# CITY OF ALBUQUERQUE

RE: **Las Ventanas at San Isidro**  
**3735 San Isidro NW**  
**Grading and Drainage Plan**  
**Engineers Stamp Date 3/23/16 (G13D031)**

**Subject:** FW: Candelaria Plaza Addition

Based upon the information provided in your submittal received 1-13-2016, the above referenced Grading and Drainage Plan cannot be approved for Site Plan for Building Permit, Building Permit, or ESC Permit (Grading Permit), until the following items are addressed:

ENGINEER'S SEAL  DAVID SOULE P.E. #14522	LOT 10B1 AND LOT B2 CANDELARIA PLAZA ADDITION	DRAWN BY JDG
	GRADING AND DRAINAGE PLAN	DATE 03-23-06
 Rio Grande Engineering 1606 CENTRAL AVENUE SE SUITE 201 ALBUQUERQUE, NM 87106 (505) 872-0999		SHEET # 1 OF 1
		JOB #

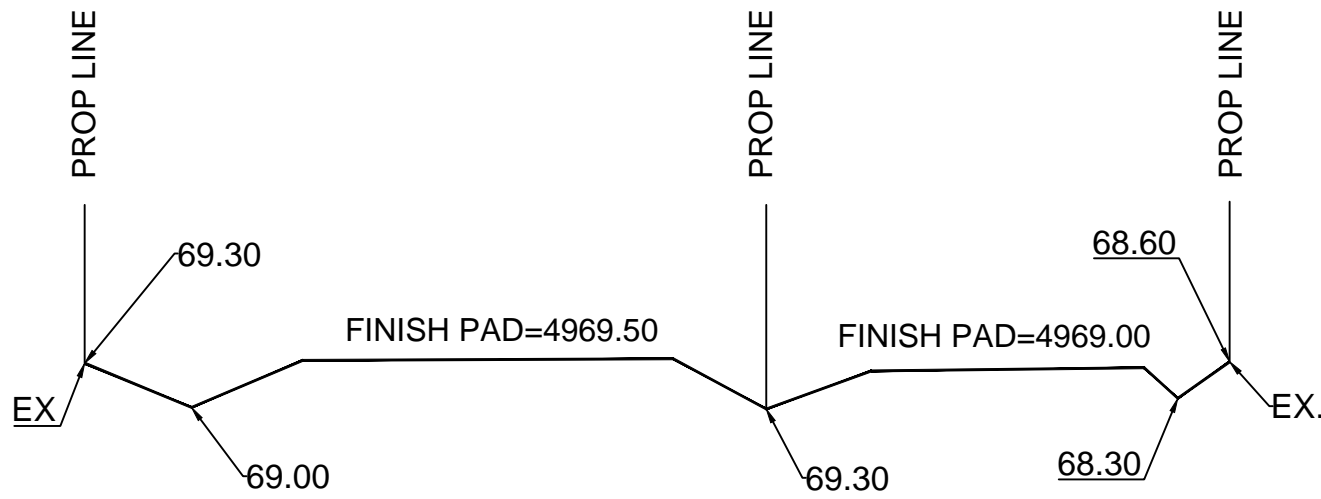
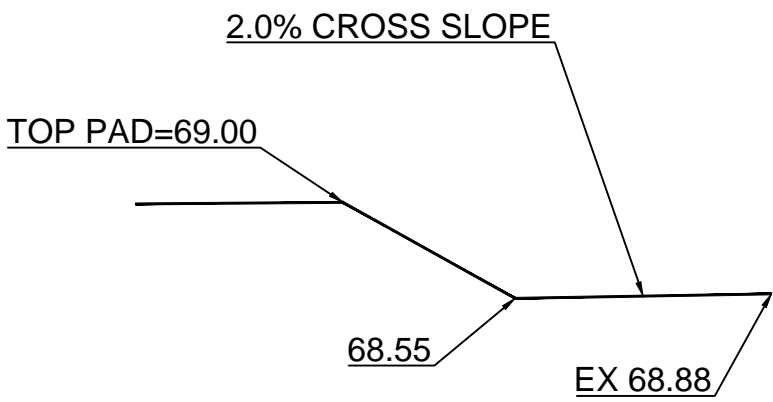
1. Drainage calcs were omitted ( [WE HAVE ADDED TO THE PLAN](#))
2. New spot elevations to cluttered, remove majority of spots. ([WE HAVE REMOVED MOST EXISTING ELEVATIONS TO ELIMINAT](#)
3. FF for lot 10-B1 should be at 4969.50. ( [WE HAVE ADDED THE FINISHED FLOOR ELEVATIONS TO ALL LOTS](#))
4. Label existing buildings. ([WE HAVE LABELED](#))
5. Show roof flows. ([WE HAVE SHOWN](#))
6. What is E note at existing buildings? ( [WE HAVE REMOVED THE KEY NOTE](#)
